HISTORIC AND DESIGN REVIEW COMMISSION

HDRC CASE NO: 2022-130
ADDRESS: 334 W ELSMERE PLACE
LEGAL DESCRIPTION: NCB 3967 BLK 2 LOT E 25 FT OF 3 & W 25FT OF 4
ZONING: R-5,H
CITY COUNCIL DIST.: 1
DISTRICT: Monte Vista Historic District
APPLICANT: Tom Krulevitch
OWNER: Peter & Susana Krulevitch
TYPE OF WORK: Exterior modifications, construction of a rear addition, rear accessory structure modifications and addition, site modifications
APPLICATION RECEIVED: February 10, 2022
60-DAY REVIEW: Not applicable due to City Council Emergency Orders
CASE MANAGER: Stephanie Phillips

The applicant is requesting conceptual approval to:

A-1

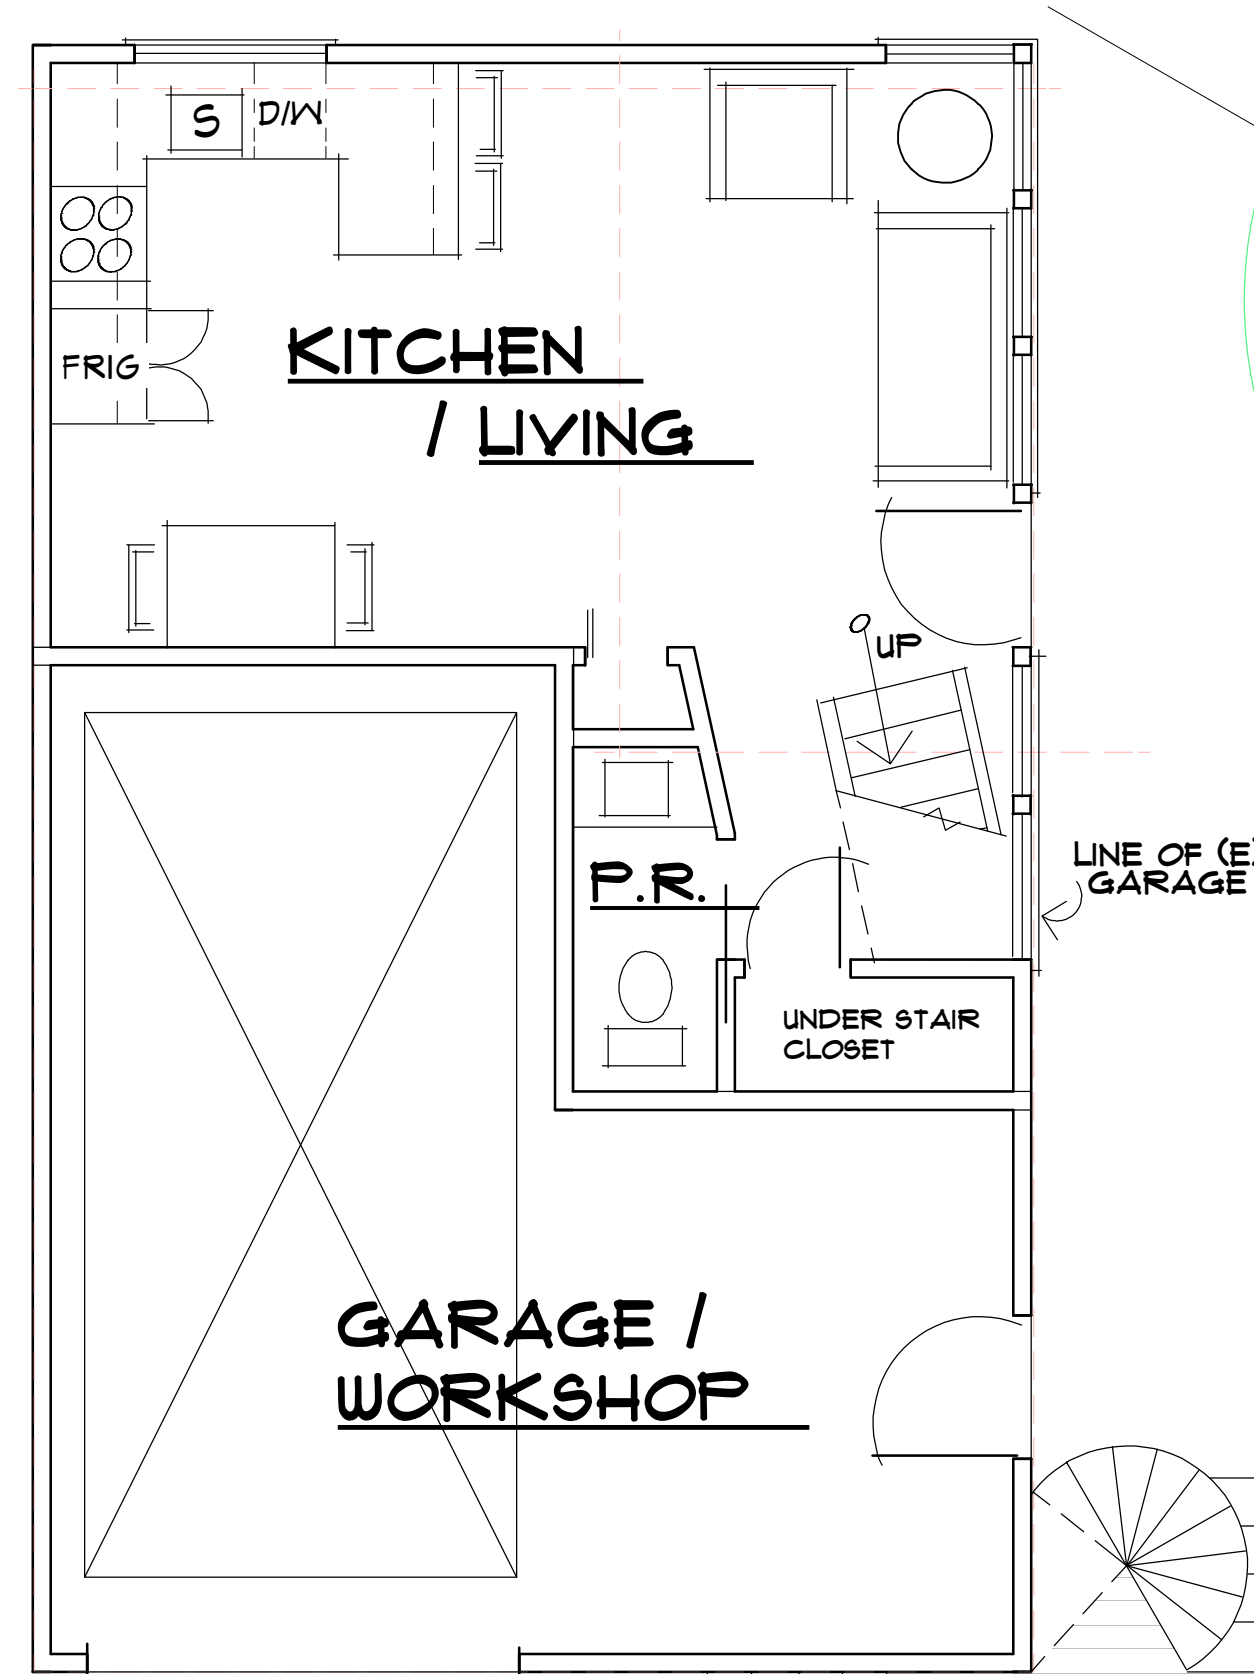
- c. FRONT PORCH MODIFICATIONS – The applicant has proposed to modify the existing front porch configuration. The current porch features an arched shed overhang and a concrete pad that is slightly larger than the overhang. The proposal will not affect the overhang. The proposal includes removing the existing steps and pad and extending the uncovered porch to the full width of the front façade. Short walls with faux column bases will be included. Per the Guidelines, front porches should be retained. Design replacement elements, such as stairs, to be simple so as to not distract from the historic character of the building. Do not add new elements and details that create a false historic appearance. The porch configuration appears to be original to the structure and is characteristic of other structures of a similar design in the Monte Vista Historic District and nearby neighborhoods of a similar development period. Staff does not find the modifications consistent with the Guidelines.

- e. ADDITION: FOOTPRINT – The applicant has proposed to construct a 1-story rear addition. According to the Historic Design Guidelines, new additions should never result in the doubling of the historic building footprint. Staff generally finds the footprint to be consistent based on the limited conceptual documentation, but requires final, dimensioned documentation to make a complete recommendation.

- i. That the applicant retains the existing front porch configuration as noted in finding c.
- ii. That the applicant provides clear, measured, dimensioned drawings that clearly convey what will be retained and what elements are new for both the addition and rear accessory structure modifications as noted in findings d, h, and j.

A-2

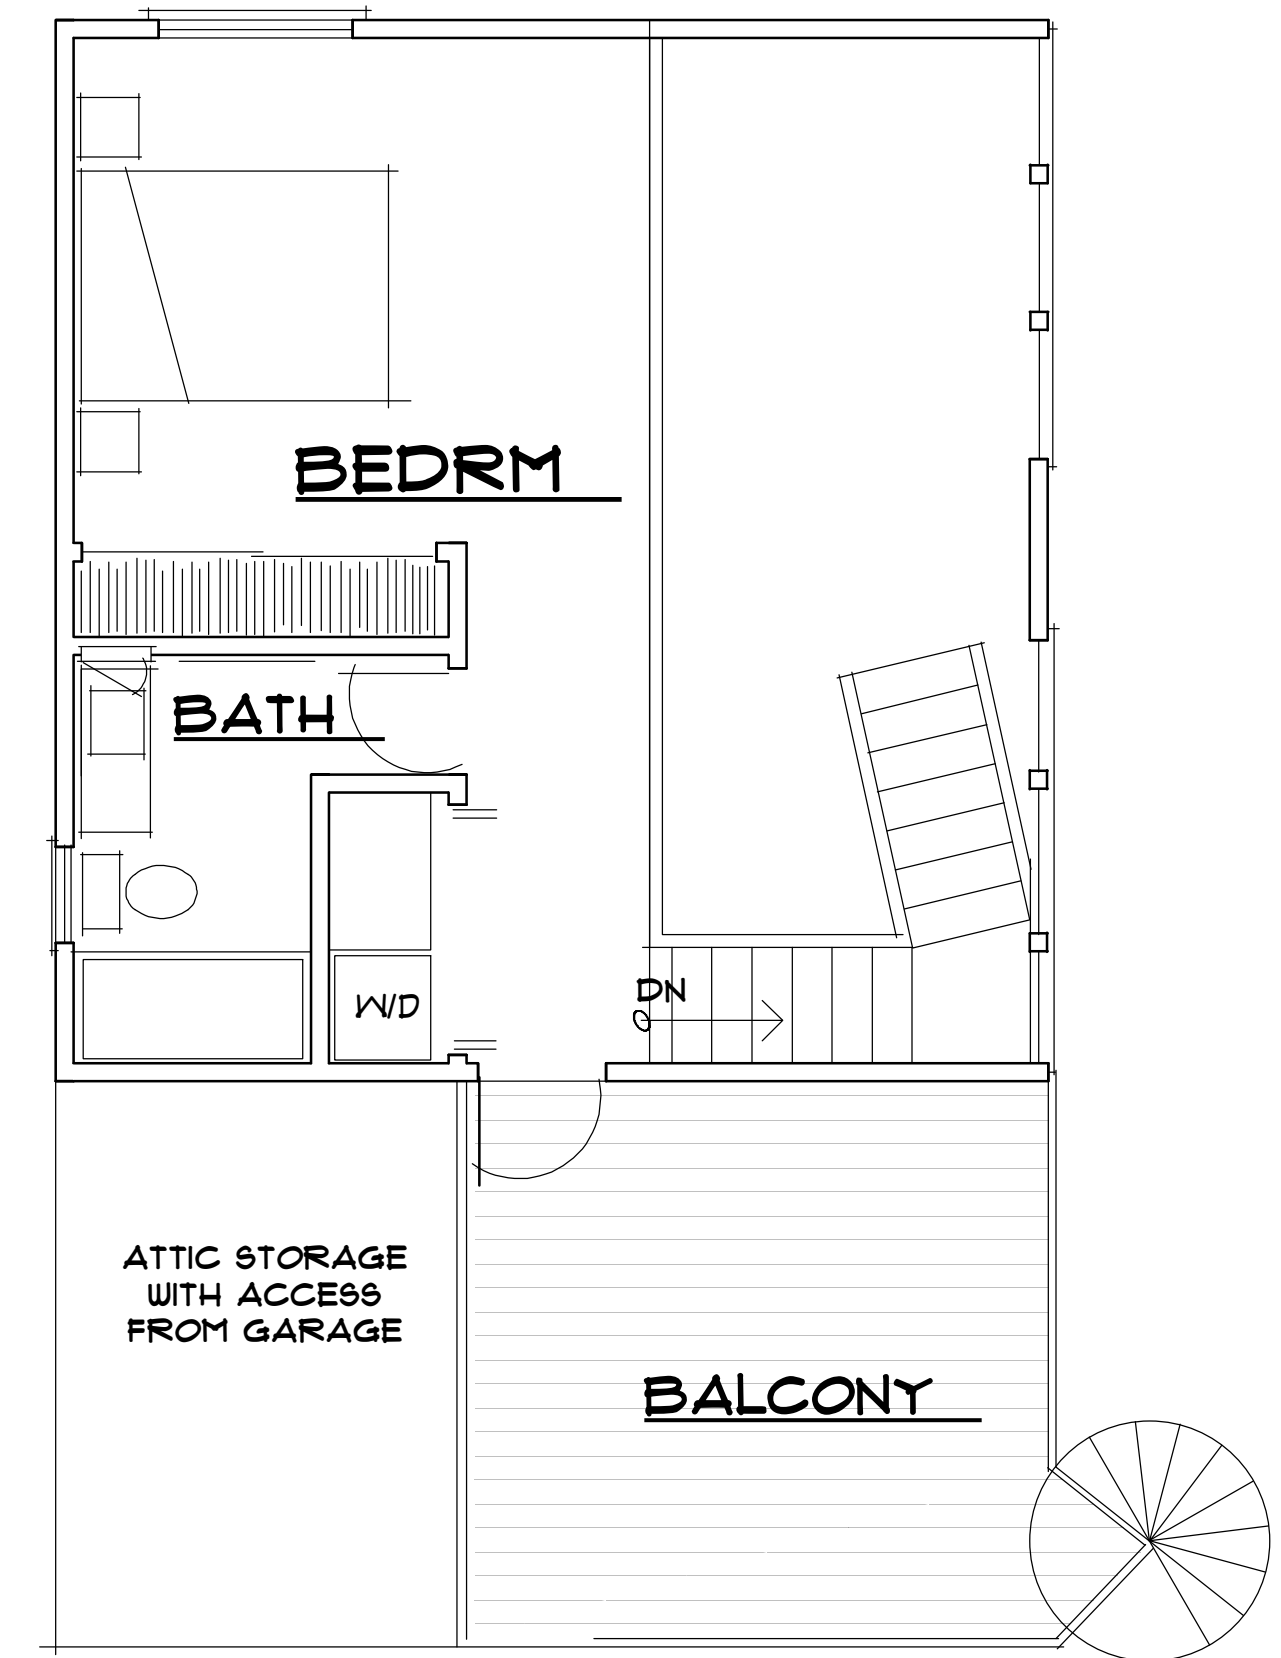
- j. **REAR ACCESSORY STRUCTURE MODIFICATIONS** – Per the submitted documents, two walls of the existing rear garage will be removed, resulting in new footprint to support a second story addition and additional exterior modifications. The two remaining walls will be retained and incorporated into the new design, which features a taller primary roofline, a new fenestration pattern, and new exterior garage doors facing the street. At this time, staff does not find the proposal conceptually appropriate due to limited visual clarity, unclear drawing convention, and an incomplete understanding of exactly what materials will be retained from the existing garage. Staff finds that applicant should aim to maximize material salvage from the walls to be removed for reuse in the new design and submit a clear salvage and reuse plan, in addition to measured, dimensioned drawings. Staff also finds that the applicant should propose modifications that are consistent with the Guidelines for Additions pertaining to roof forms, fenestration patterns, massing, scale, and materials.

- v. That the applicant submits a rear accessory structure proposal that includes clear elevations and additional information on which materials will be retained in the new design as noted in finding j. The drawings should also indicate the height of the rear structure relative to the primary structure.

- vi. That the applicant incorporates roof forms, materials, and fenestration patterns into the rear accessory structure modifications that are consistent with the Guidelines as noted in finding j.

MAIN ELEVS PROPOSED

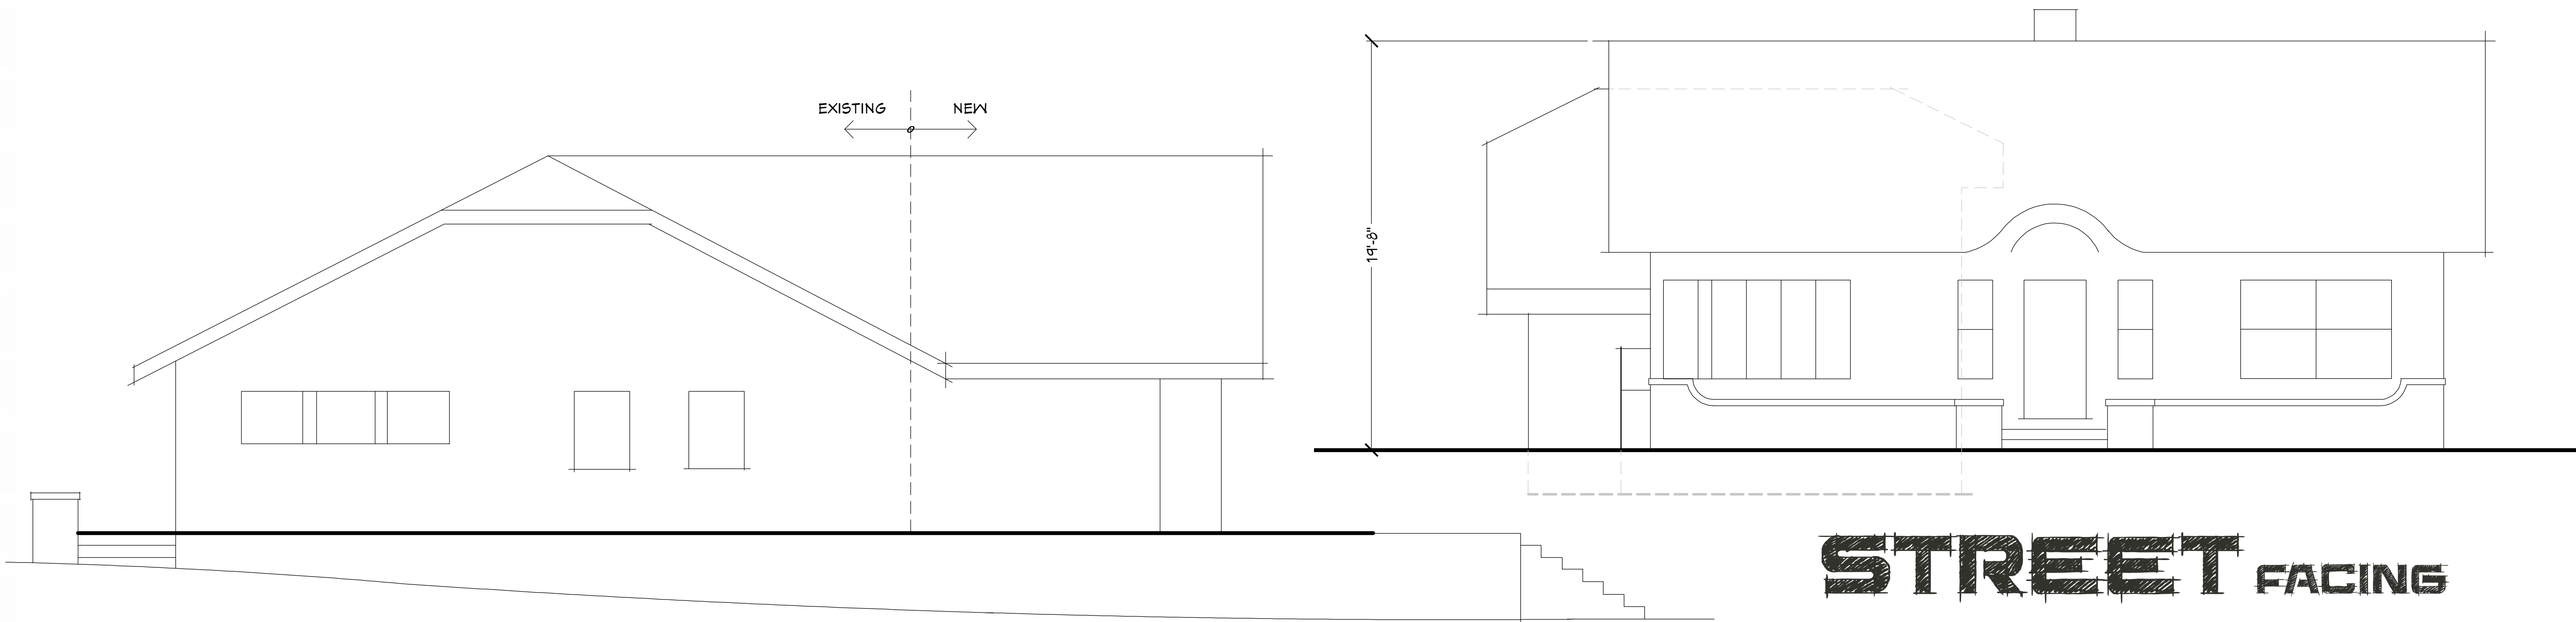
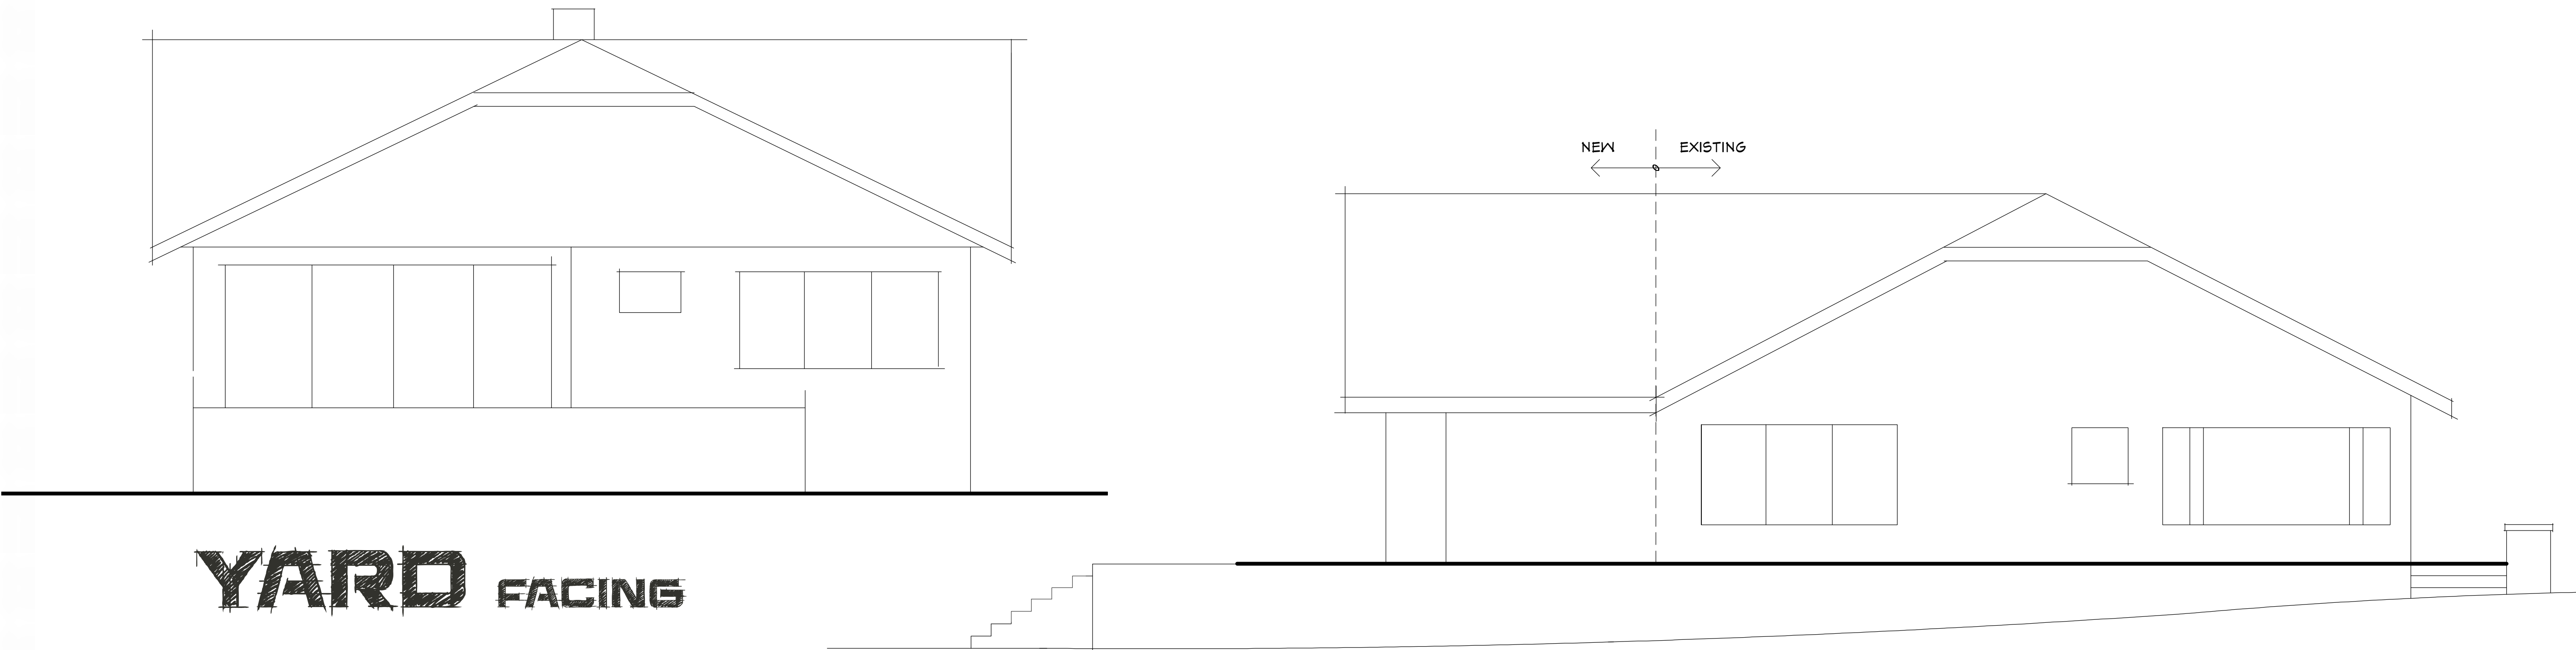
- f. ADDITION: SCALE AND MASSING – The applicant has proposed to construct a 1-story rear addition. According to the Historic Design Guidelines, the height of additions should be subordinate to the primary structure or, at minimum, align with the primary ridge line. Staff generally finds the height consistent with the Guidelines based on the submitted documentation.

- g. ADDITION: ROOF – The applicant has proposed to install a standing seam metal roof on the addition to match the primary structure. The roof will feature a gable configuration. Staff finds the proposal conceptually consistent with the Guidelines.

- h. ADDITION: WINDOWS AND DOORS – Per the submitted documentation, the addition will feature accordion-style doors and a set of three windows on the rear elevation. The right and left elevations of the addition do not currently feature fenestration. According to the Historic Design Guidelines, new windows on additions should relate to the windows of the primary historic structure in terms of materiality and overall appearance. Windows used in new construction should relate to those commonly found

within the district in terms of size, profile, and configuration. As noted in finding d, the applicant should reclaim windows to be removed for the addition where feasible. While no material is expressly prohibited by the Historic Design Guidelines, a high-quality wood or aluminum-clad wood window product often meets the Guidelines with the stipulations listed in staff's specifications and the recommendation if new windows or doors are needed. Staff recommends that the applicant explore adding fenestration to the left and right elevations for final approval.

- iii. That the applicant salvage and reuse the windows to be removed for the rear addition as noted in findings d and h.
- iv. That the applicant explores adding fenestration to the right and left elevations of the addition for final approval as noted in finding h.
